**STATEMENT OF THE
MANUFACTURERS OF EMISSION CONTROLS ASSOCIATION
TO THE OCCUPATIONAL SAFETY AND HEALTH STANDARDS BOARD'S SECOND
PROPOSED 15-DAY MODIFICATIONS TO THE STATE STANDARD TITLE 8,
DIVISION 1, CHAPTER 4, REGARDING VEHICLE EXHAUST RETROFITS**

July 20, 2011

Figure 1: Retrofit reduces masking caused by muffler OEM muffler outlined in red.

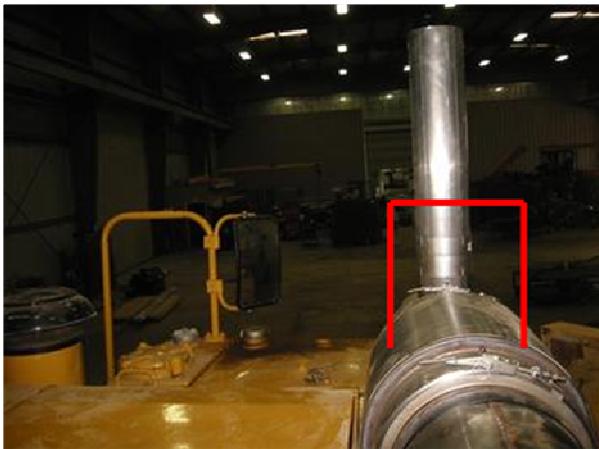
IV. MECA requests that staff clarify the handling of certain equipment like scrapers or graders where the entire side of the vehicle is blocked from view even beyond a 40 inch perimeter by the hood of the vehicle itself.

This scenario creates an inconsistency in regulatory law where a piece of equipment that failed the visibility test would be allowed to operate in a workplace as long as it does not have a retrofit installed. In some vehicles like scrapers, graders and haulage vehicles, an operator must rely on the OEM installed parabolic mirror to insure that a worker is not at risk of being injured next to the vehicle. A retrofit positioned to the side of a scraper or grader would not block any more of the 40” boundary than the original vehicle itself. **Since these vehicles are not designed to travel sideways, some limited masking equal to or less than the OEM muffler that is replaced should be allowed. This would be similar to the provision allowed for retrofits installed to the rear of excavators.** MECA provides the attached example of a scraper where the retrofit (Figure 1) clearly improves the visibility over the OEM designed muffler (Figure 2). The current language would not allow this retrofit installation because it may block a portion of the 40” perimeter line. **Similar to the treatment of exhaust stacks, we request that the regulation allow retrofit installations that result in equal or less masking than OEM components that they replace.** Figures 1 and 2 also demonstrate that on some equipment, like this scraper, the visibility to the entire side of the vehicle is blocked by the hood unless the driver relies on the OEM mirrors that are provided for that purpose. In staff’s response to JK5, they argue that “Mr. Kubsh provided no evidence that vehicles with mirrors and an obstructed view to the rear are as safe as vehicles with mirrors and an unobstructed view to the rear”. MECA provides this example, (Figures 1 & 2), to show how the use of an OEM mirror makes the vehicle safer whether the view is obstructed or unobstructed. In fact a completely unobstructed view provides no visibility within 40 inches of the sides of the vehicle without the use of the mirror.
